Kitchen Property - Rough Grading Only

Drainage Study Approval Letter

Subject: TDS for Kitchen Property
Location: West of Coke between Racel and Brent
APN: 125-09-602-003
Sec, Township, Range: S09, T19S, R60E
Flood Zone & Panel: Zone X per 1734F, revised November 16, 2011
Application Tracking #: 17-9606

Drainage Study Comment Letter

FIGURE 6
EXISTING CONDITION BASIN MAP
KITCHEN PROPERTY

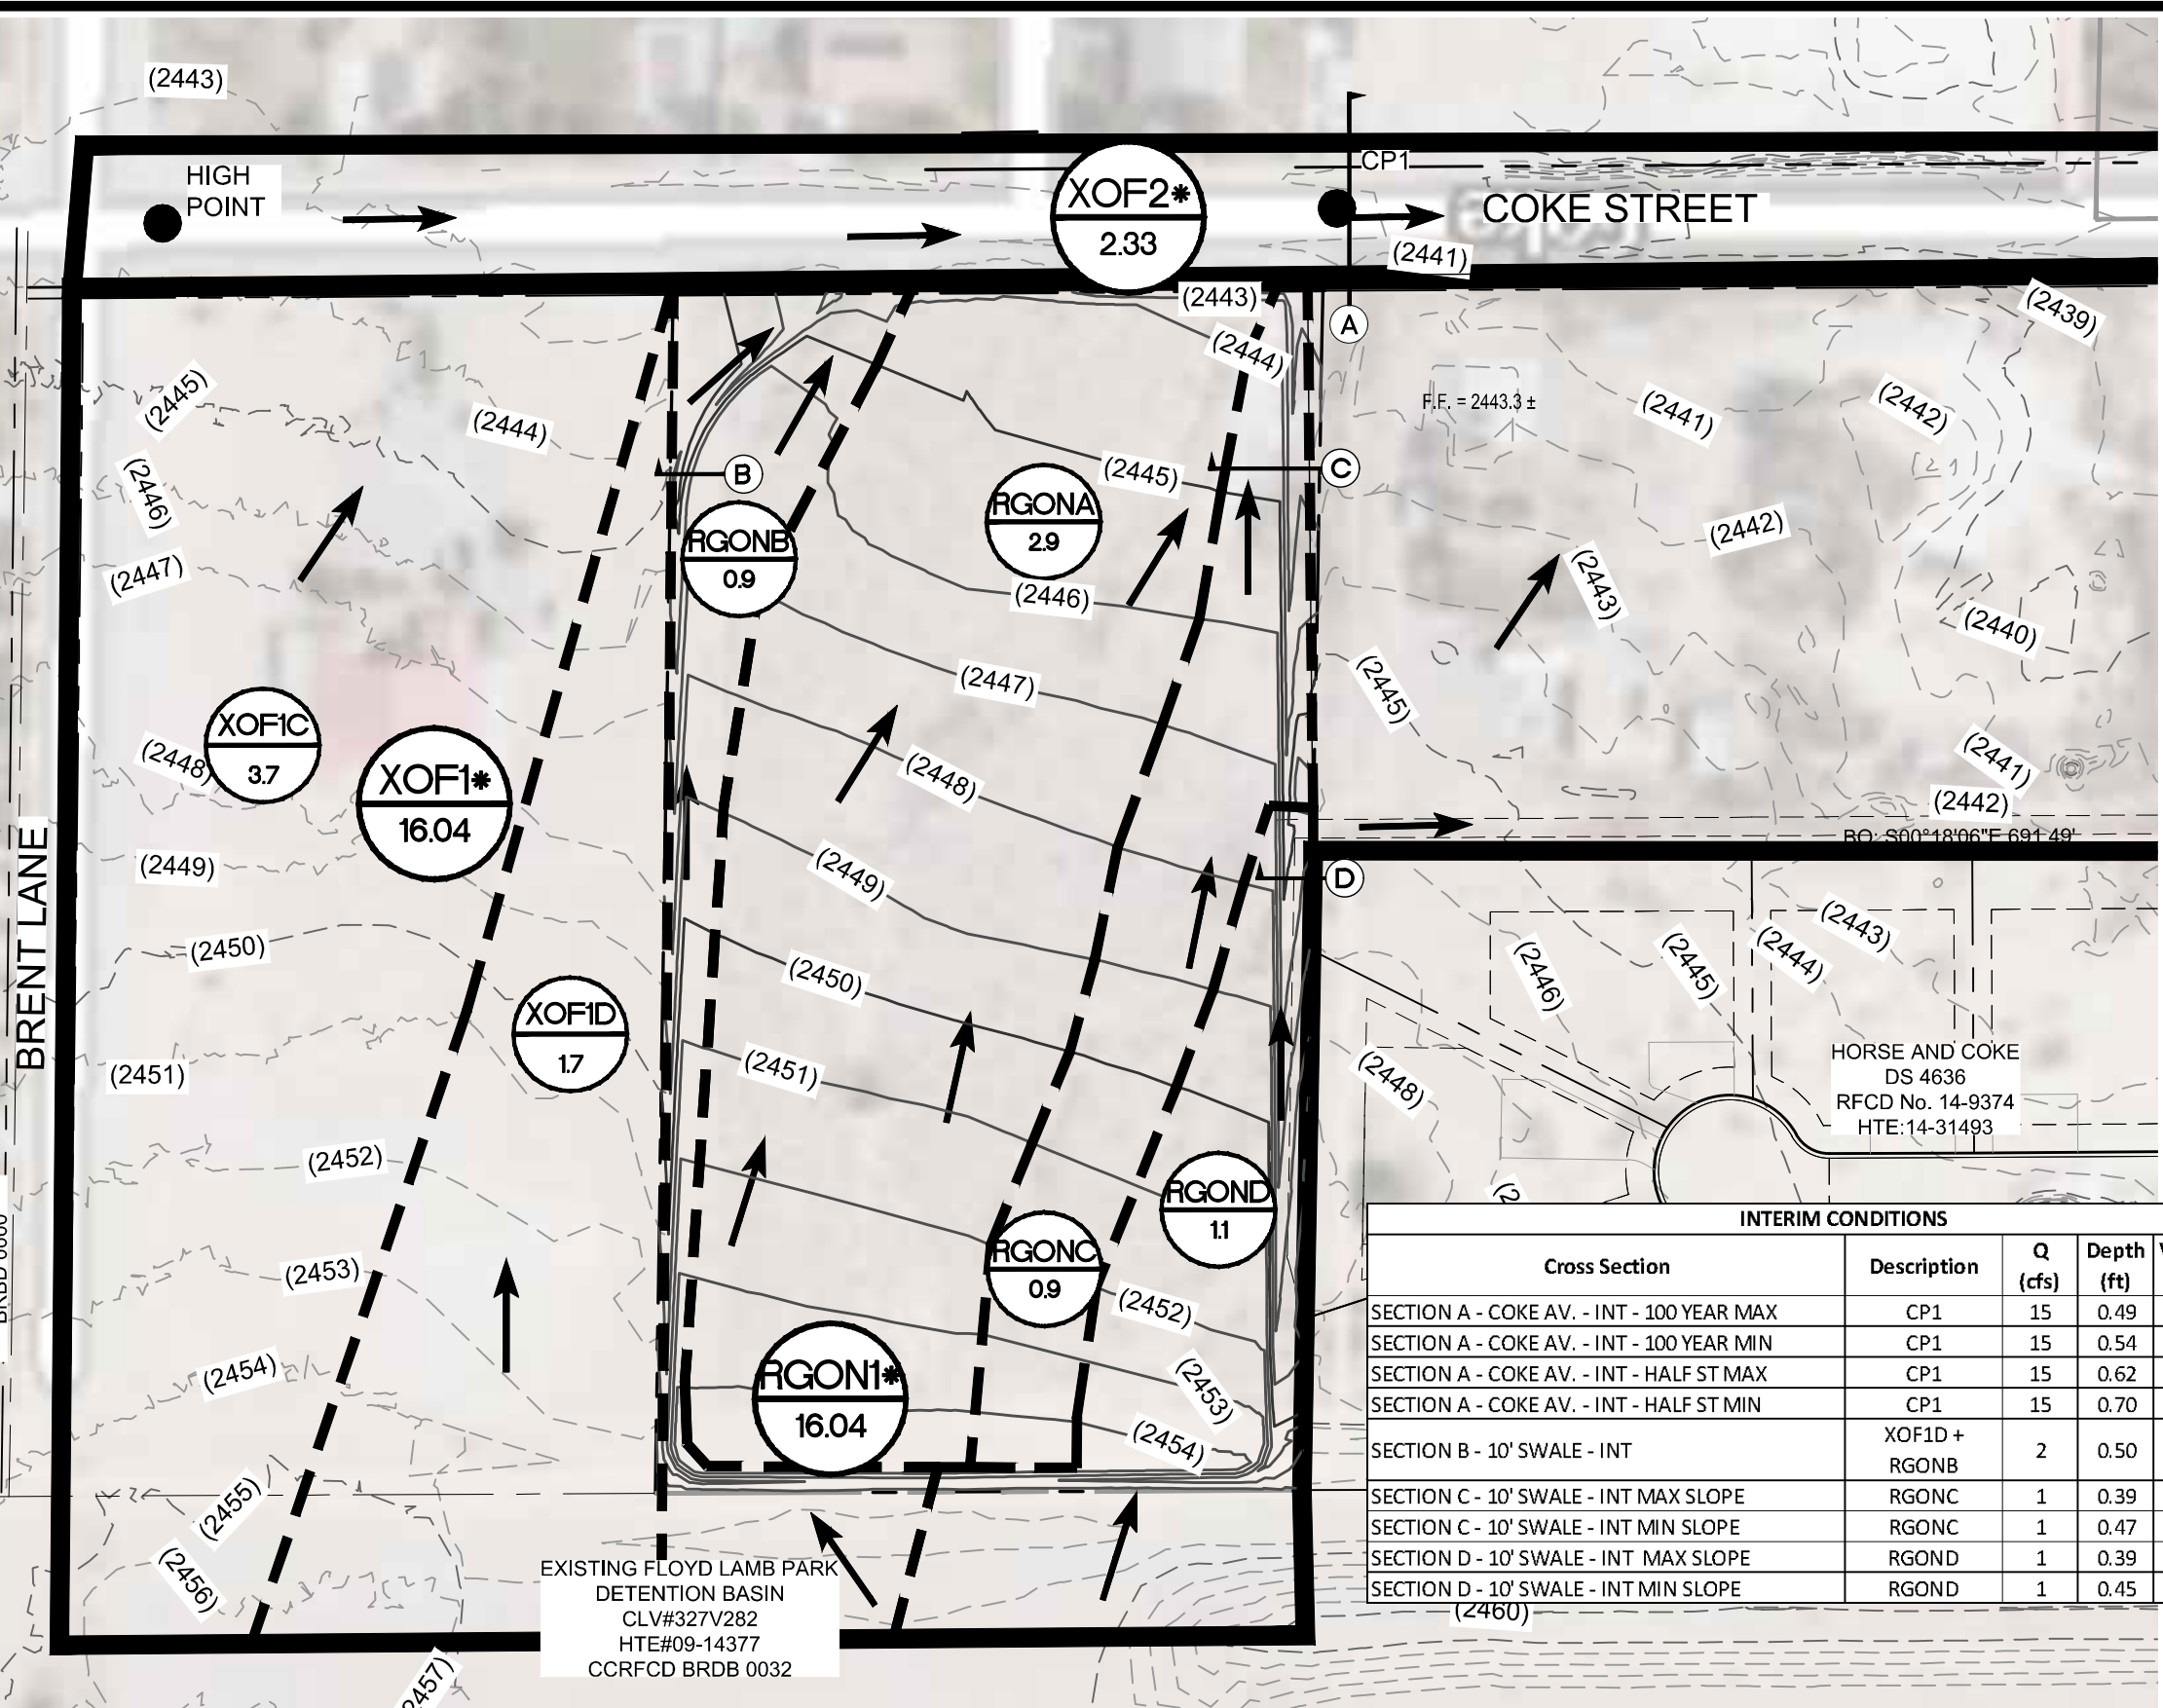
Comment 6: The north arrows as shown on Figures 6 and 7 are oriented incorrectly.

Figures 6 and 7 have been revised and resubmitted with the north arrow oriented correctly. Figures 6 and 7 can be found in the Appendix.

**FIGURE 7 - ADD1
DEVELOPED CONDITION BASIN MAP
KITCHEN PROPERTY**

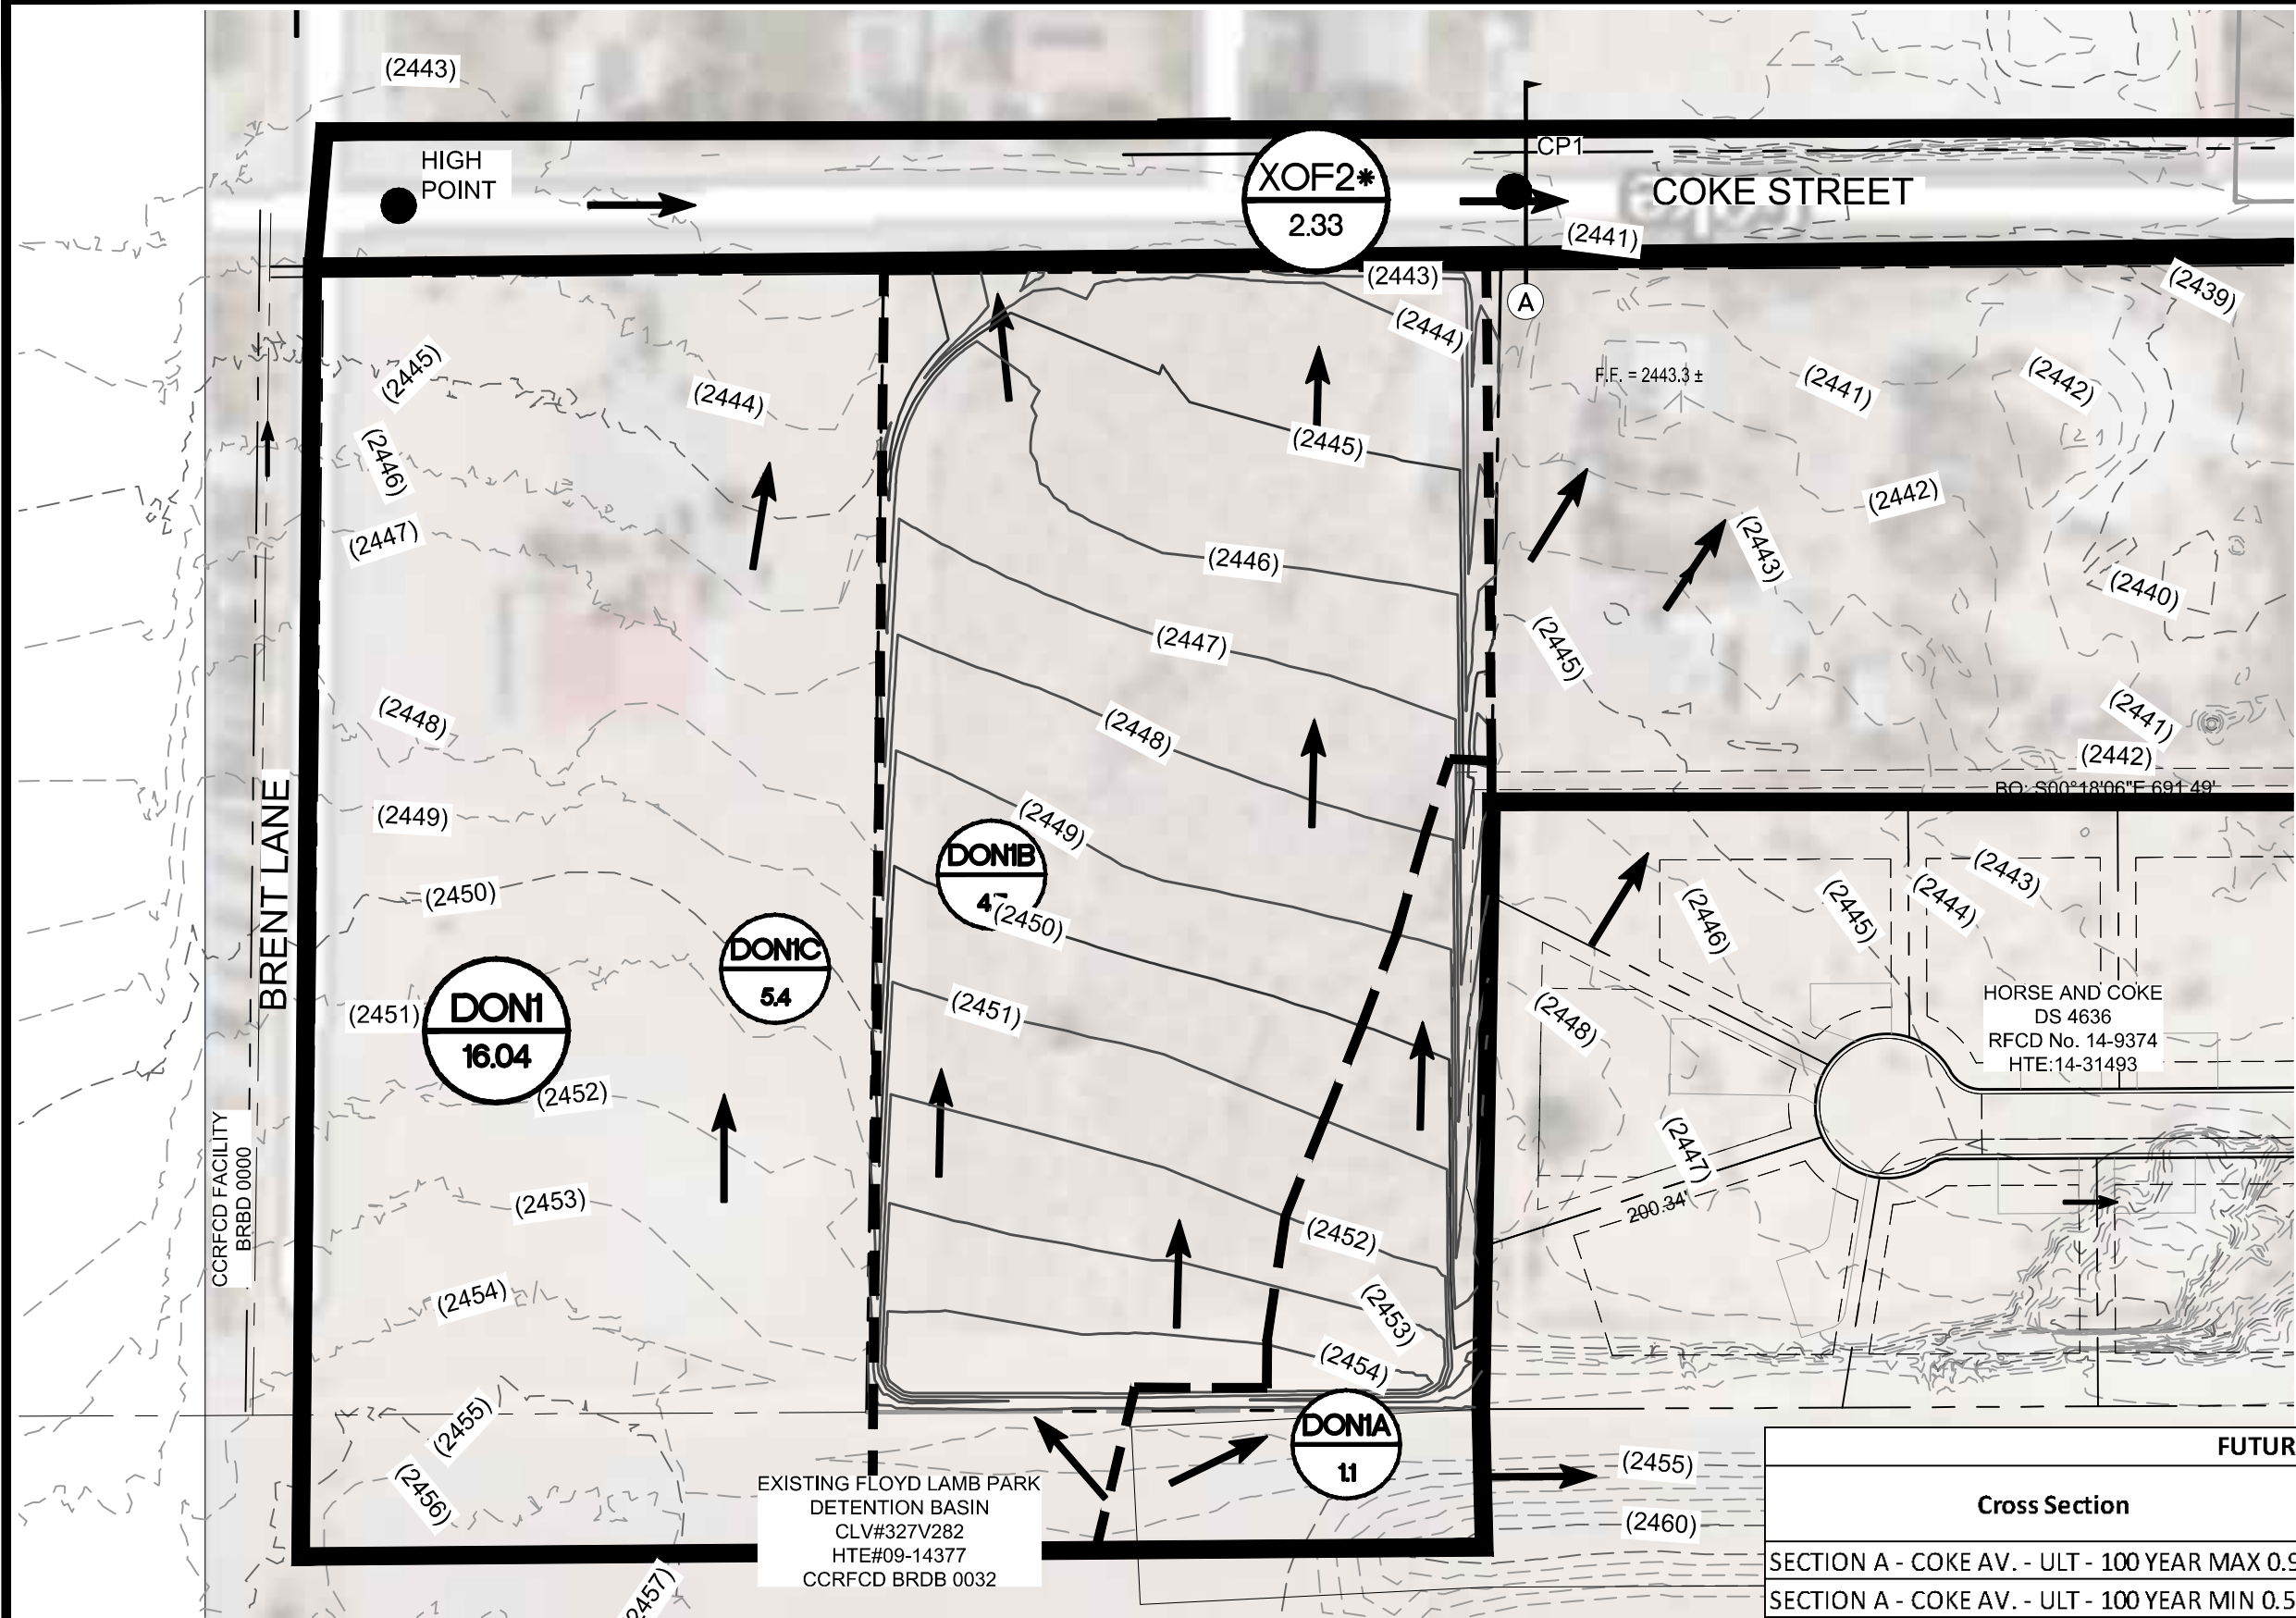
Comment 9: Review the hydraulic sections. The geometry do not appear to match elevations as shown on the plans and it appears that depths will be higher than calculated.

Also, the onsite proposed grading has been revised for this submittal, and the interim prorated onsite subbasins have been revised to match the proposed grading. The cross section flows for sections C and D have been revised accordingly. A summary of the cross section calculations can be found on Figure 7 in the Appendix.

Cross Section for SECTION A - COKE AV. - INT - 100 YEAR MAX

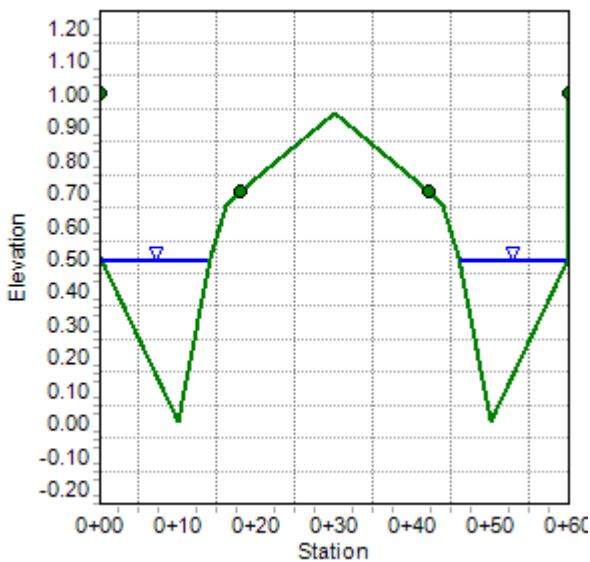
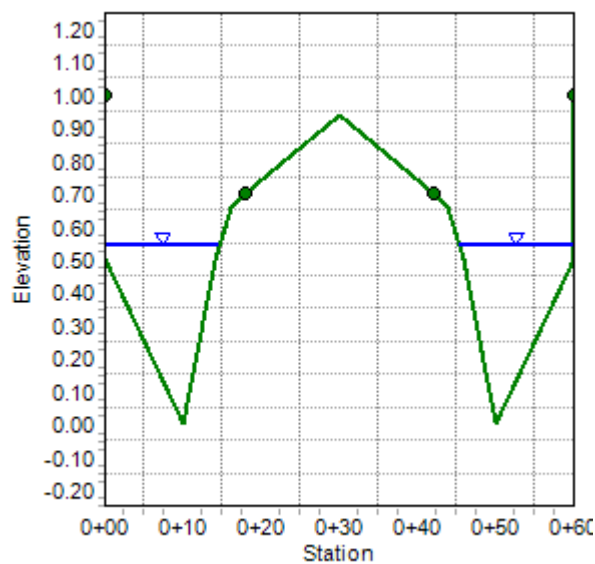
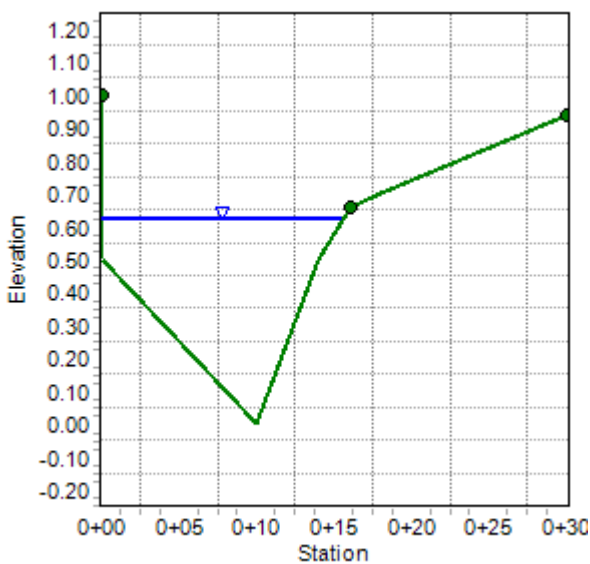
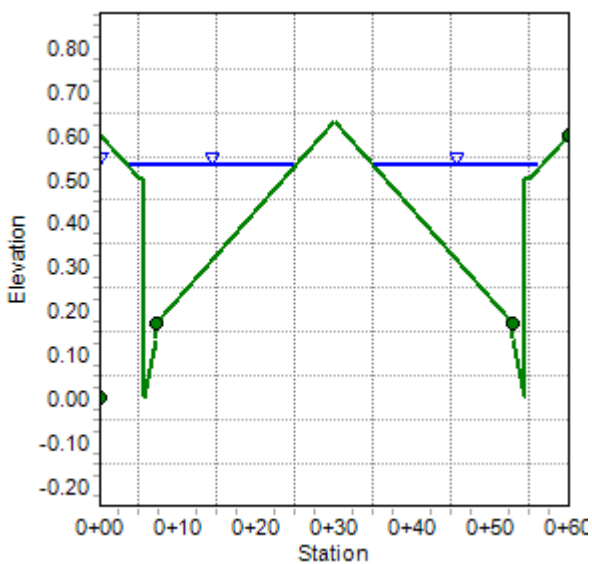
Comment 10: Provide a hydraulic section for the minimum slope in Coke Road.

Normal depth calculations for the ultimate street section for Coke Street, a 60-foot right-of-way, have been included for the maximum (0.95%) and minimum (0.53%) longitudinal slopes at cross section A. A summary of the basin flows and normal depth calculations can be found on Figure 8 in the Appendix.
